November 22, 2024

Project: **Proposed 38-Lot Woods at Viewcrest Plat**  
352 Viewcrest Road, Bellingham, WA

Subject: **Geohazard Review Addendum – Stormwater Outfall Plan**

## Figure 3

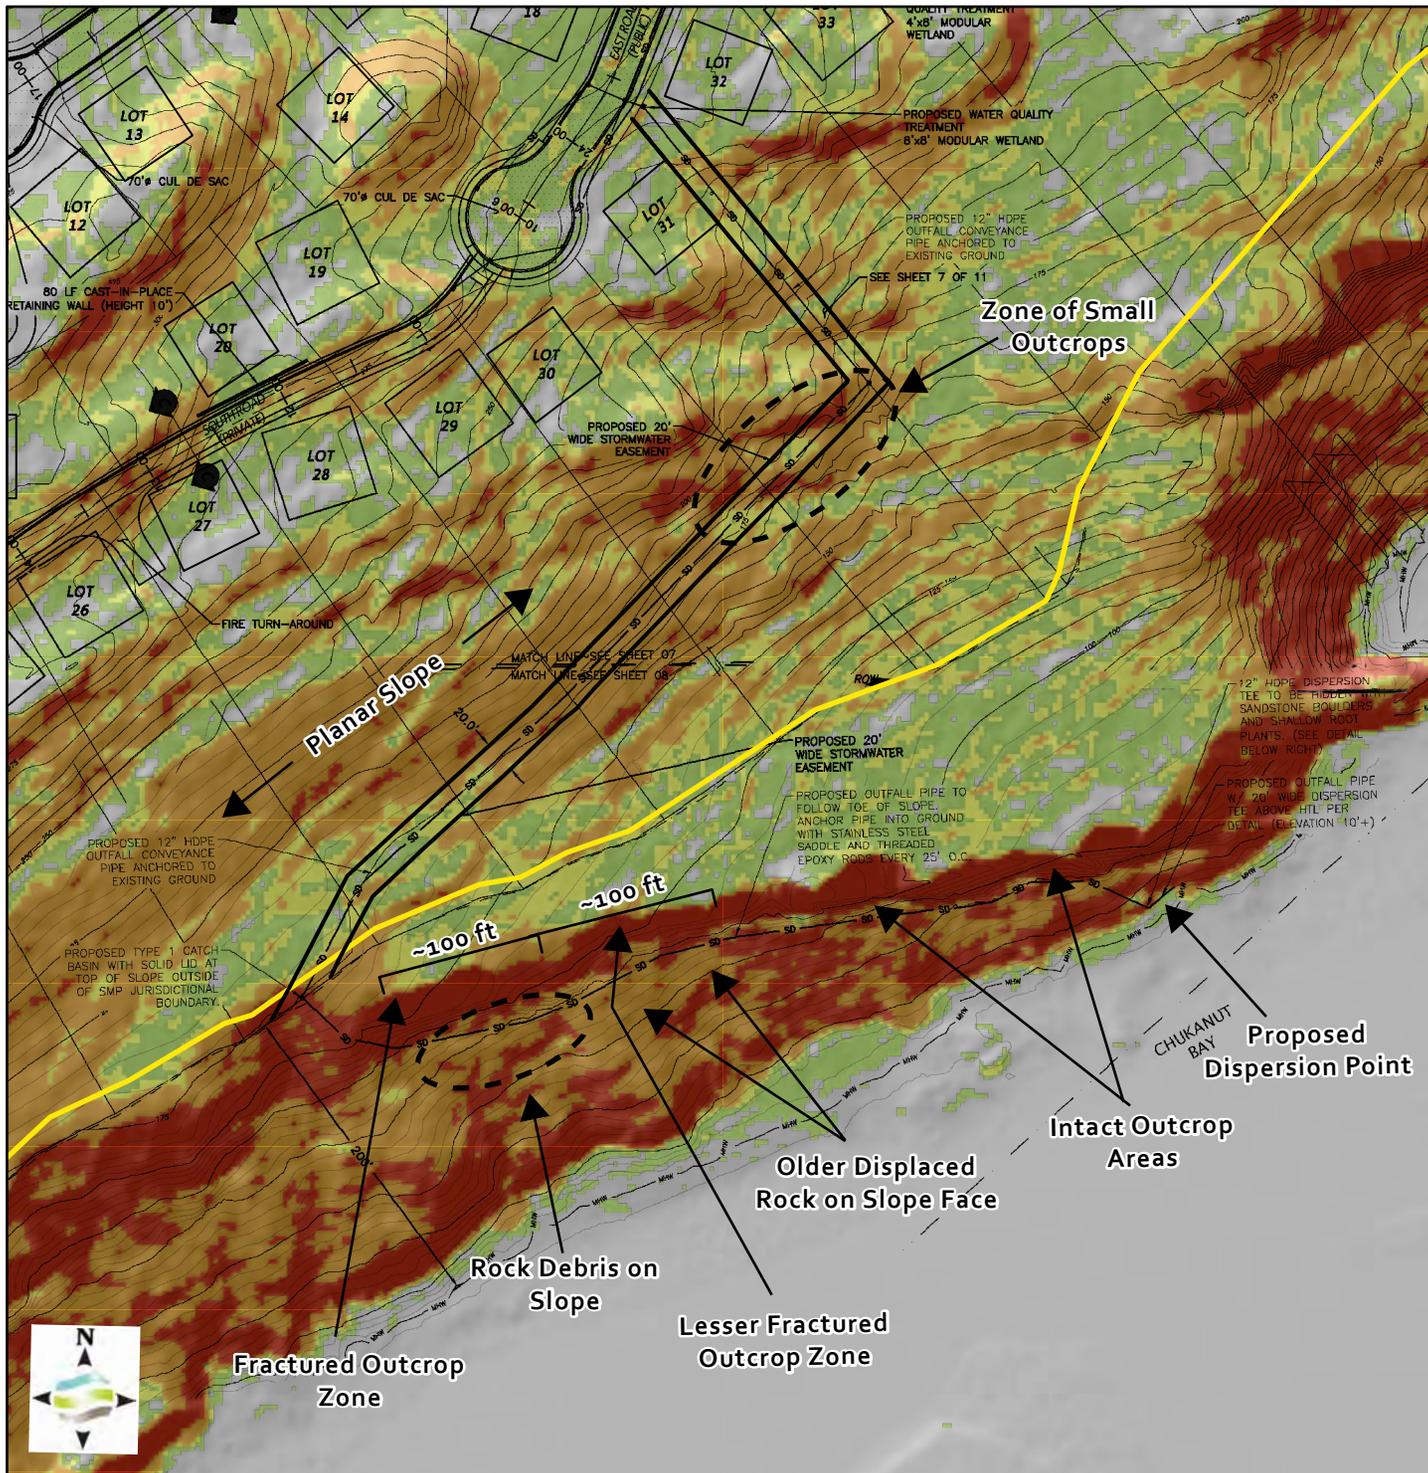
Weather conditions at the time of the visit were sunny and dry. Vegetation allowed for adequate access along the area of interest. A draft version of the attached Southern Region map (Figure 3) was produced overlaying outfall drawings on GIS slope-shade data to easily identify features in the field. The GIS map was loaded into a GPS-based application (Avenza) for continuous location tracking. As we traversed along the alignment, we observed surrounding slope stability conditions. We also assessed for potential

The lower slope extent of the tightline path includes a short top segment about 40' – 50' long from the top-of-bluff catch basin that is oriented downhill. This transitions into a main section around 500' long that traverses across the slope near the base of an exposed sandstone bedrock cliff. The last segment of about 50 feet length travels downhill to the location sited for dispersion on a large vegetated sandstone pad just above the Ordinary High Water Mark (OHWM) and High Tide Line (HTL). Refer to Figure 3 for illustration.

Two areas of greater-than-typical challenge for tightline installation have been identified which pose unique difficulties that must be addressed in final design and construction. The approximate locations and extents of these areas are noted on Figure 3. For the purposes of this review, we have assumed that the general routing concept as shown on the Preliminary Plat drawings will be pursued for final design.

- We encourage additional detailed reconnaissance and collaboration during final design to assess for routes for optimal avoidance of specific outcrop obstructions. For instance, an angled segment through Lots 30 and 31 may be considered as an alternative to the right-angle junction shown.

- One method to mitigate rock fall hazard from the cliff band is to adjust the alignment to traverse across the slope further away from the cliff exposure below elevated hazard areas. The hazard of rock fall directly impacting a downhill pipe generally lessens with distance from the source.

- A downslope shift on the order of 50 feet is interpreted to be sufficient to minimize rock fall impact risk, based on conditions observed during the recent reconnaissance. We recommend an alignment shift below the elevated hazard areas be considered for final design. Site conditions should be re-observed during final design to optimize the outfall path for rock fall protection.

**THE WOODS AT VIEWCREST**  
 ESTATE PLANNING  
 SITE IMPROVEMENTS  
**ROAD & STORMDRAIN PLAN**

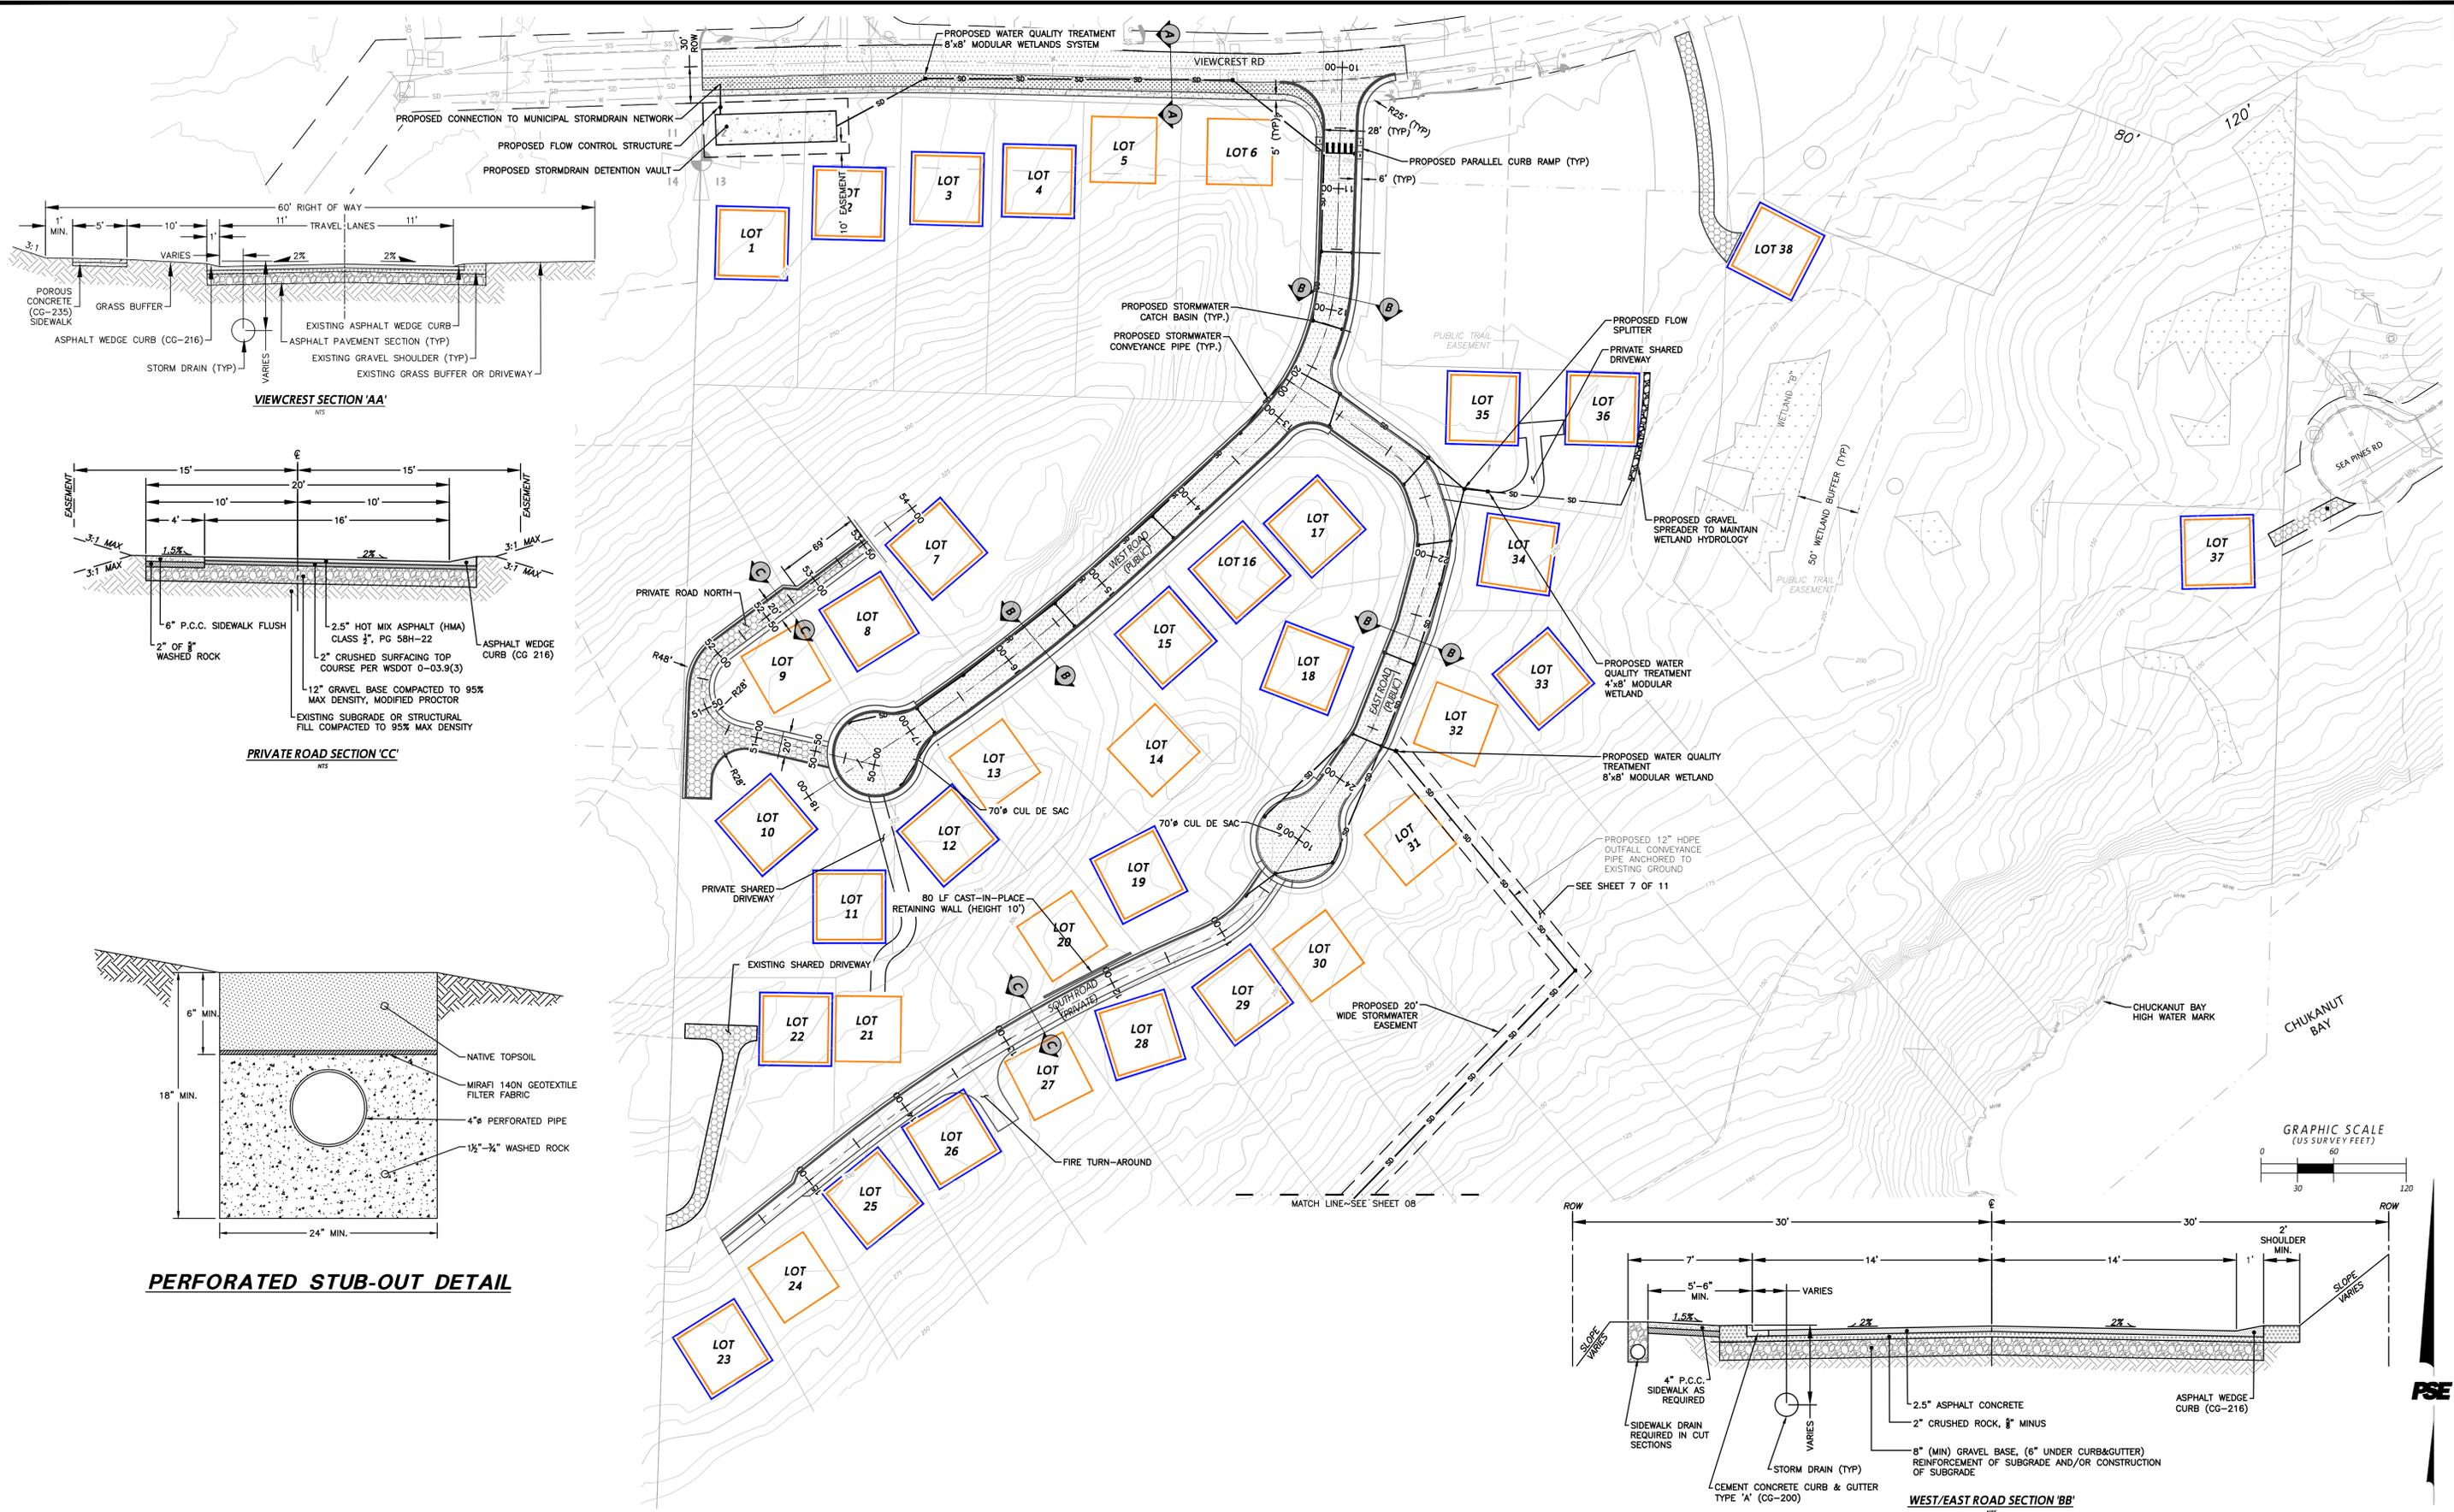
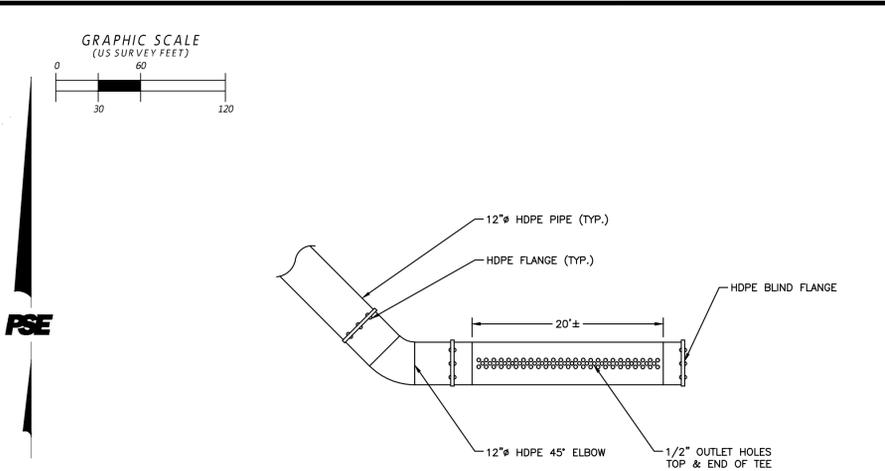
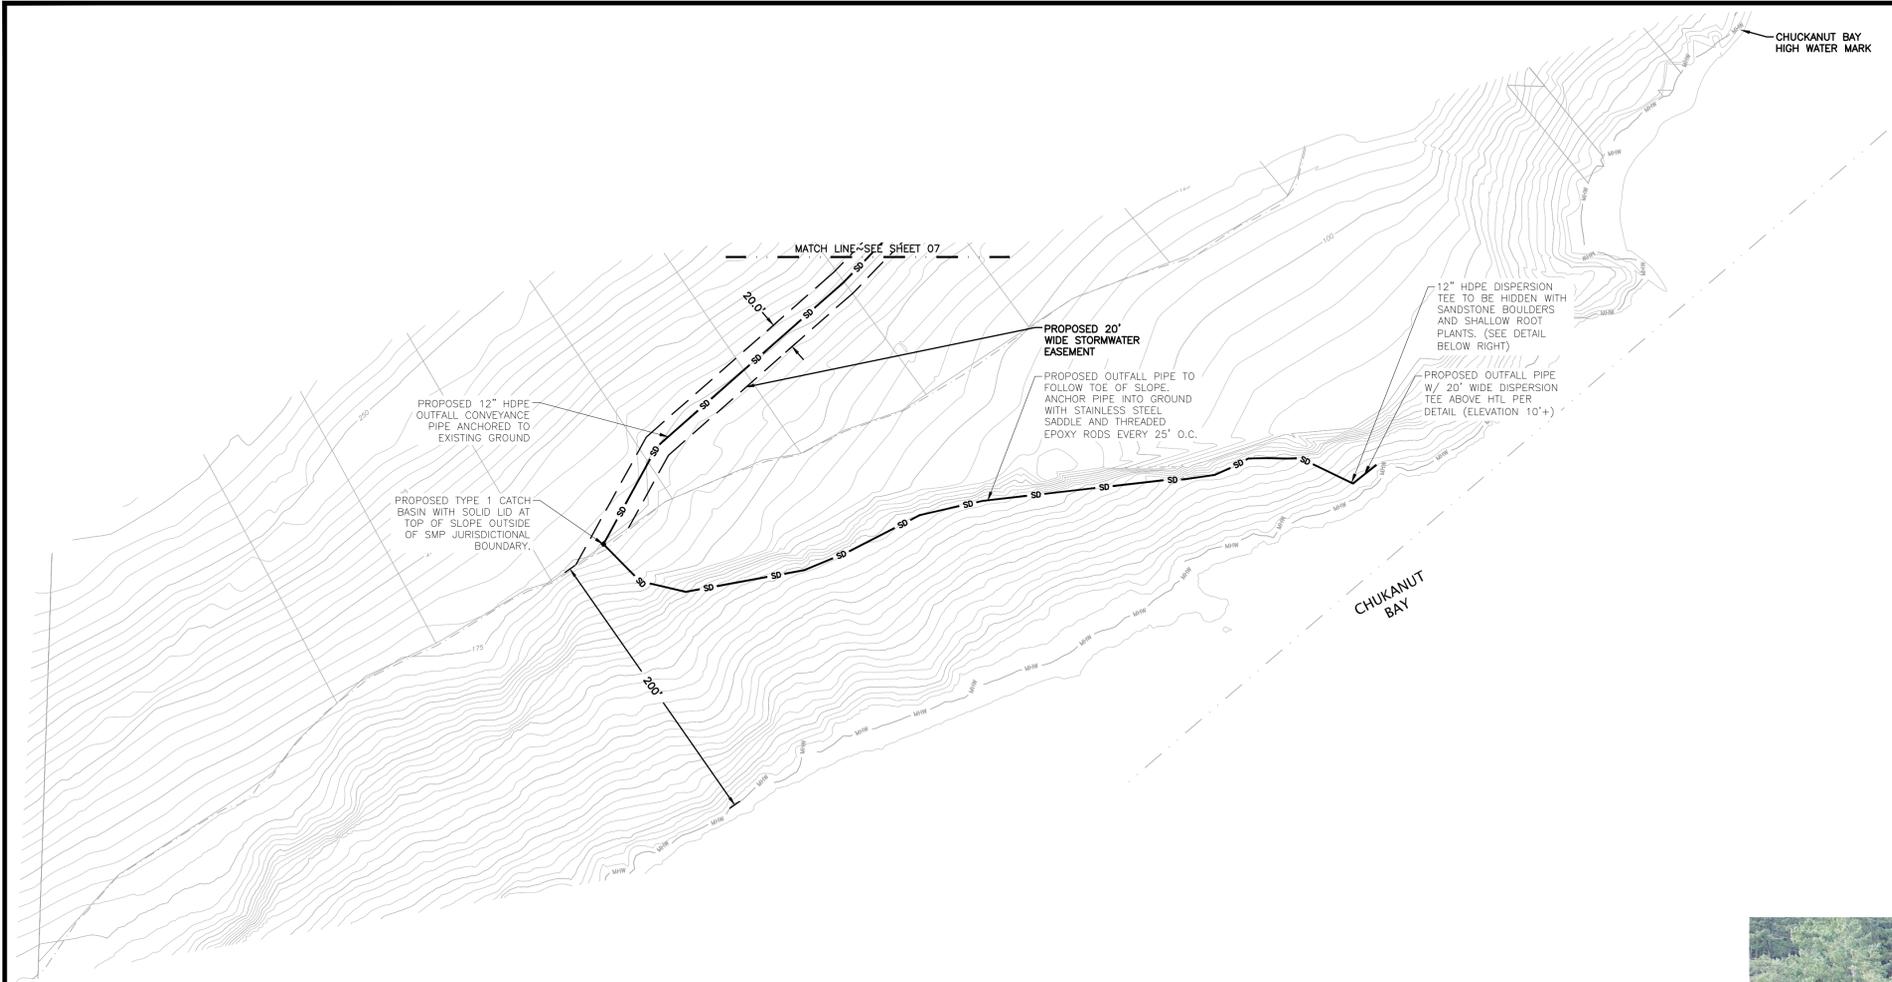
Preliminary Plat civil plans by Pacific Surveying & Engineering (PSE; Sheets 7 & 8) illustrate the project will employ two off-site conveyances. Northern portions of the plat that drain towards Viewcrest Road will be routed through a modular wetland treatment system and flow control detention vault, then out to the existing municipal storm drain network. Central and southern portions of the plat that slope southeastward will have stormwater collected and routed through a separate modular wetland treatment system, then down the south slope through a main tightline to a dispersion point next to the shoreline. One on-site release is shown, consisting of a split-flow to a dissipation trench above a wetland area intended to help maintain post-development wetland hydrology.

The upland extent of the tightline begins with an approximately 250' long segment that extends directly down-gradient from near the East Road Cul-de-Sac (between Lot 31 & 32) to a 90-degree right turn. This is followed by a laterally contouring segment that is about 550' long extending to a catch basin near the top of the lower shoreline bluff.

**THE WOODS AT VIEWCREST**  
ESTATE PLANNING  
SITE IMPROVEMENTS  
**STORMWATER OUTFALL**

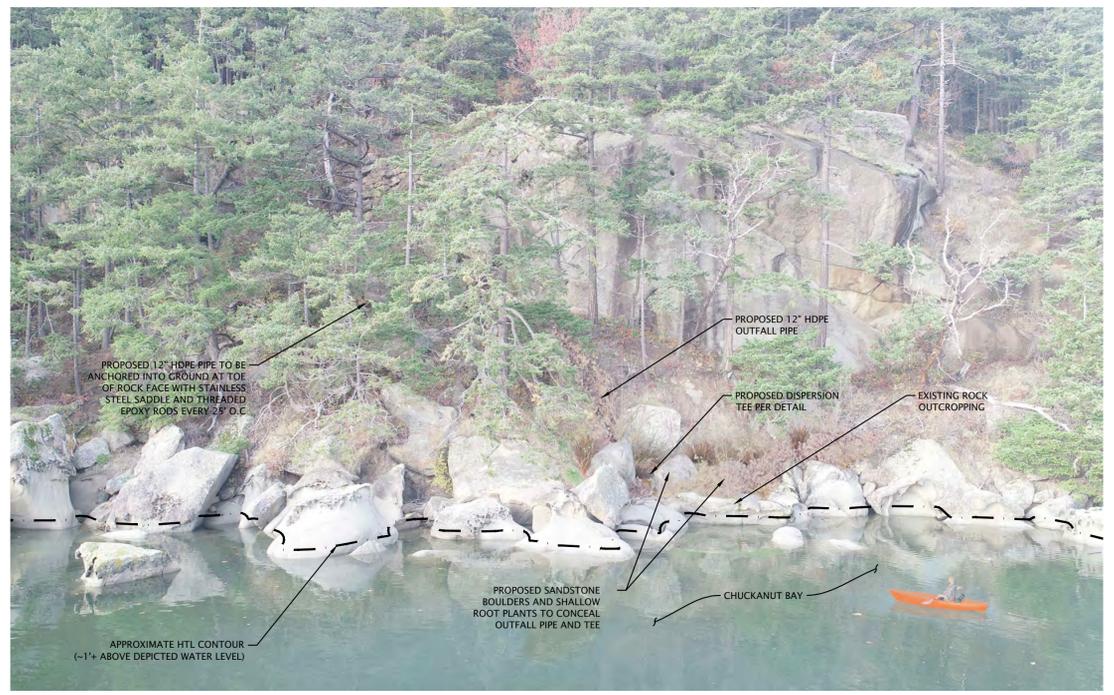
**Bluff Slope Rock Fall Zone:** After descending onto the lower bluff slope, the conveyance piping is proposed near the base of the tall rock exposure. While the eastern majority of this rock face appears intact with a low rock fall risk, the western portion appears prone to occasional rock fall from fractured outcrops. In particular, the first approximately 100 feet along the cliff face displays an elevated risk of incidental rock fall. This is evidenced by common rock talus on the underlying slope which generally dissipates out from the outcrop. The next roughly 100 feet of slope also has common older rock debris but little evidence of recent activity.

- Constraints on pipe elevations appear to allow for such a downhill alignment adjustment while retaining suitable fall to reach the proposed terminus location. Our observation and map review of the conveyance zone also indicate there is adequate room along moderate slope areas to allow for an adjusted pipe alignment.

- Alternatively, or in tandem with a shift, the conveyance pipe should be constructed with additional shielding from rock fall impacts as needed for the final design location. Possible options include natural barriers (use of existing rock talus and large boulders for upslope shielding), or sleeving / covering the HDPE pipe with another material for impact protection where necessary (like concrete or steel casing).

- Design the shoreline Dispersion Tee so that it is sufficiently secured and resistant to damage from storm surge wave events.
  - Anchor the Dispersion Tee directly to the rock shelf by use of epoxied dowels and collars to the extent that it is not at risk of loss or dislodgement from a maximum potential storm wave magnitude.

- Select a Dispersion Tee material that is suitably resistant to potential impacts from wave-generated debris anticipated for the location. High wave activity is not expected in this area due to the BNSF causeway which acts as a breakwater during storm events.
